Ocean Sweater Ind. (Pvt). Ltd. (Extension)

Islampur, Joydebpur, Gazipur.

3 March 2025

1. Executive Summary

Observation 3: Corrosion on steel members (Shed-1).

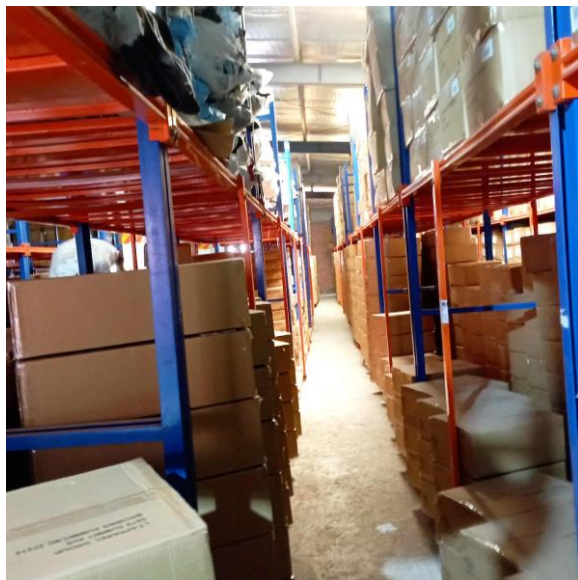
Description: Corrosion was observed on steel members at several locations. The building engineer is required to remove the corrosion and provide rust-proof paint on steel members.

4.	Corrosion on steel members (Shed-1).	The building engineer is required to remove the corrosion and provide rust-proof paint on steel members.	within 6 weeks
